pd-trigger — Design Document

ai-ee v1 pipeline

Board review (P8 adversarial) - pd-trigger

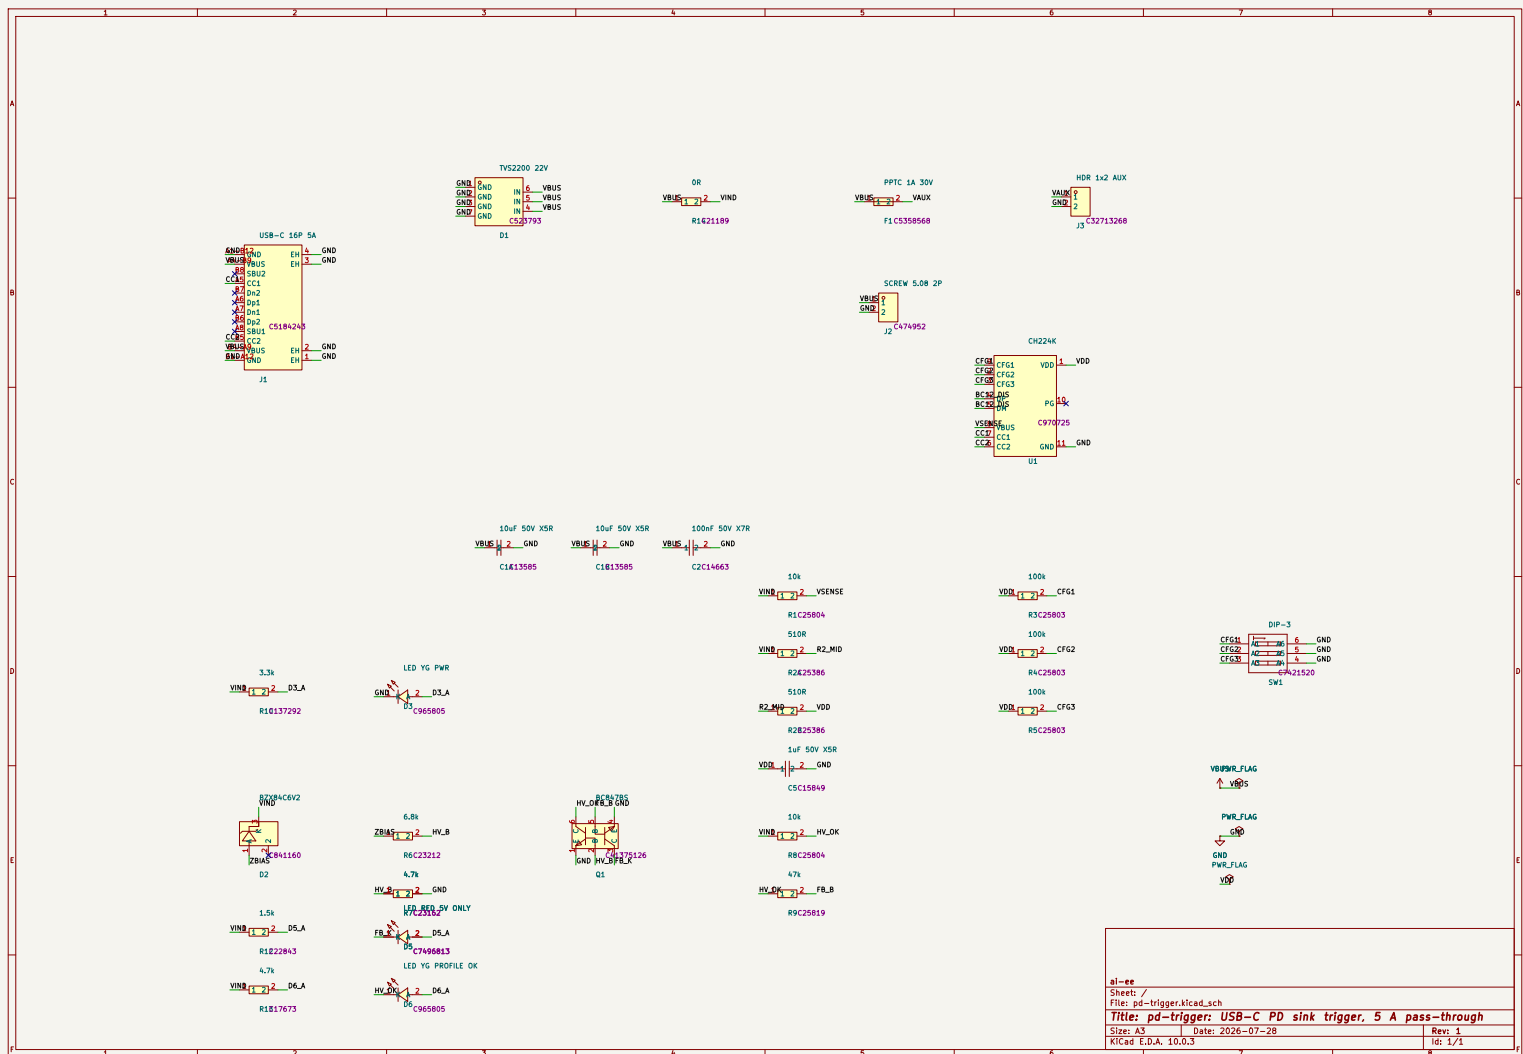
W1 dp-dm-short-at-chip: architecture's PD-only short (/BC12.DIS) ACCEPTED by the reviewer as hardware-SAFER than the datasheet's connector wiring (removes a 21V-onto-3.8V-abs-max fault path). Cost: no QC/BC legacy support - the board is "PD sources only"; goes on B.SilkS + order docs. W2 vdd-worst-corner: true worst case 0.979mA at 4.4V low-line all-straps- closed vs unpublished CH224K IDD - bounded by WCH's own reference circuit; V1 bring-up step: measure VDD at the 5V profile; contingency = both 510R -> smaller (documented floor 600R total). Bring-up addenda: buzz out Q1 E/B/C once (clone PDF JS-gated; Nexperia- standard pinning verified as the compatibility claim).

reports/render_final/top.png

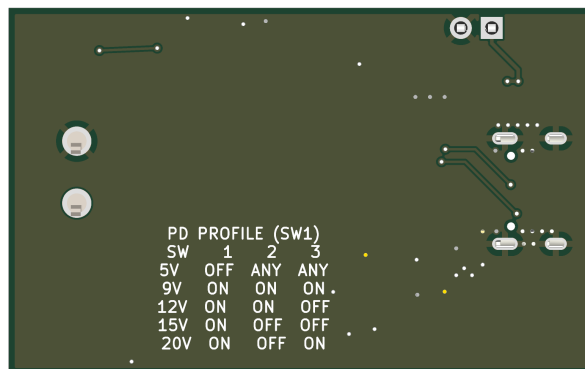
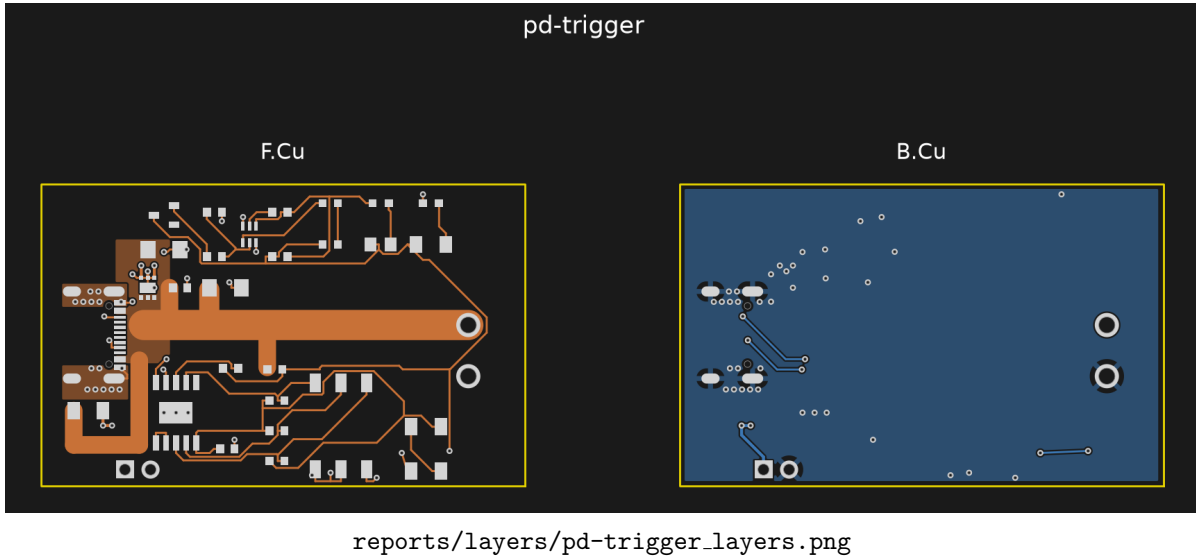
E1 - 5 A return chokes at J1's GND contact pads (error, checker-blind by design D7)

The 4 GND cable contacts land on two merged SMD pads (F.Cu only): A1-B12 at (17.63,39.31) and B1-A12 at (17.63,45.71), nominally 2.5 A each at the 5 A rating. Their ONLY copper into the B.Cu return pour:

- A1-B12 (top): a 0.2 mm wide, 2.7 mm long F.Cu chain (3 segments) into shell pad 1's THT barrel, plus one 0.6/0.3 via whose annulus grazes the pad corner by ~0.05 mm (etch-tolerance-level). 0.2 mm at 2 oz = 0.80 A capacity at 10 C rise (pipeline model); at 2.5 A the same model gives ~133 C rise (short-neck heatsinking will moderate this, but it is a >3x overcurrent on the model's own terms). ~13.6 squares = 3.3 mohm.
- B1-A12 (bottom): a 0.2 mm x 1.3 mm trace into ONE 0.6/0.3 via. The board's own via budget (constraints via_amps 0.5) says 2.5 A needs 5 vias; there is 1. Shell pad 4 sits 0.32 mm away but is NOT connected on F.Cu - its copper does not help.

Architecture D7/power_tree structural requirement ">= 10 vias at J1's GND pads" (the stated substitute for keeping GND out of power[] so check_current stays quiet): not delivered. DRC cannot see it (0.2 mm is netclass-legal), check_current cannot see it (GND undeclared), check_return_path no-ops (no high_speed key). Failure mode: sustained 5 A at any profile heats the two necks far past the 10 C design intent; long-term trace/joint fatigue, intermittent ground, and full return current cascading onto the surviving 0.2 mm chain. Fix is cheap at P9: an F.Cu GND spandrel bonding each contact pad to its shell pad (the VBUS pour top edge is at y 39.7 - the strip above it, and the strip x < 17.2 plus the region south of y 46, are free) plus 4-5 vias per side.

E2 - Safety/waiver silk markings absent (error, promised artifact) Board-wide gr.text count is ZERO; B.SilkS carries nothing at all (both B.SilkS references in the file are the stackup layer table). Missing, each one a written promise:

- AUX 1A MAX + V+/GND at J3 (P0 answer 4 "silk-marked", V10). F1 makes overload safe-by-hardware, but polarity of the 2-pin aux header is unmarked.
- PD SOURCES ONLY (ERC waiver W1's standing condition: "goes on B.SilkS + order docs"). The waiver's silk half is currently unfulfilled.
- J2 screw-terminal polarity. Trunk lands on J2 pad 1 = the LOWER screw (board-bottom side); nothing anywhere tells the bench user which screw is V+. Reverse-wiring a load on a 100 W output is the single easiest field mistake this board can cause.

E3 - User-interface silk absent (error, promised artifact)

- The five-row profile table on B.SilkS - D3 calls silk "the user interface" and specifies the table verbatim; the bottom is a clean pour with room. Without it the ON/OFF-to-voltage map exists only off-board; a user WILL set 9 V expecting 12 V by trial and error. (Fail-safe floor: any wrong guess >= the 5 V fallback, and OFF-fail = 5 V - the mistake is bounded but real.)

- LED legends PWR / 5V ONLY / PROFILE OK (D4/V10): the render shows refdes D3/D5/D6 only. The entire P0-answer-6 "visible fallback indication" scheme is mute without the words - a lit red LED labeled "D5" indicates nothing.

W1 - J1 mouth recessed ~0.4-0.5 mm behind the board edge (warning, flagged at P6) Courtyard/silk front edge $x = 10.18$ vs board edge $x = 9.8$. USB-C receptacles are normally flush-to-overhanging; a recessed mouth lets thick/molded plug overmolds butt the board edge and hold the plug fractionally short of latch - intermittent CC, no PD, "works with some cables". On a bare bench board with arbitrary cables this is a real annoyance risk. Fix: nudge J1 -x 0.5-1.0 mm at P9 (pour edge follows; nothing else in that corridor), or accept and note in order docs.

W2 - Outline 48 x 30 mm exceeds the architecture's hard ceiling (warning, drift) Edge.Cuts = (9.8,27.51)-(57.8,57.51) = 48 x 30 mm. D9: nominal 45 x 25, "hard ceiling 48 x 28 mm"; 30 mm violates D9's own ceiling by 2 mm even though it equals P0 answer 5's literal +20 % (40x25 -> 48x30, +44 % area vs the brief's target). No digest discloses the growth past D9. Consequence is cost/footprint only, but it must be disclosed to the user at the checkpoint rather than discovered.

A1 - J2 GND pad ties to the return pour through 4 thermal spokes (advisory) J2 pad 2 (THT, 2.4 mm pad / 1.6 mm drill) connects via 4 x 0.5 mm diagonal spokes = 2.0 mm total at 2 oz -> model 8 C rise at 5 A. Legal and functional, but these are the most-loaded copper necks on the whole return after E1, at a hand-soldered joint. Recommend a solid-connect override (or a short fat GND strap) at P9; zero cost. (Verified all 4 spokes present; the VBUS pad 1 island below it is barrel-tied, normal.)

A2 - F1's VBUS feed branch is 18.3 mm long (advisory, V8 letter-violation) V8/D8 wanted all five VBUS taps hugging the run with 2-3 mm stubs. D1, C1A, C1B, C2, R14 comply; F1's feed runs 8.4 + 6.5 + 3.4 mm at 1.75 mm width to the top-left corner. Width-compliant (V8's actual purpose), carries ≤ 1 A in service; only cost is ~30 mm² of extra always-live 20 V copper. No action needed; recorded as drift.

A3 - Floating 0.65 mm² GND sliver at (20.0, 28.5) (advisory, cleanup) plane_repair's own dead-island fact (0 anchors), between J3/SW1 clearances. Cosmetic / minor DFM nit; remove at P9 cleanup or accept.

A4 - /VAUX at PPTC max-non-trip current (advisory) /VAUX routes at 0.3 mm (required 0.25 at the declared 1.0 A -> 7 C). F1's worst sustained NON-trip current is ~1.8 A -> model 27 C rise on those runs until/unless the PPTC trips. Bounded, no damage threshold approached (70-80 C copper on a 20 V node); acceptable. Recorded so nobody "fixes" it blind later.
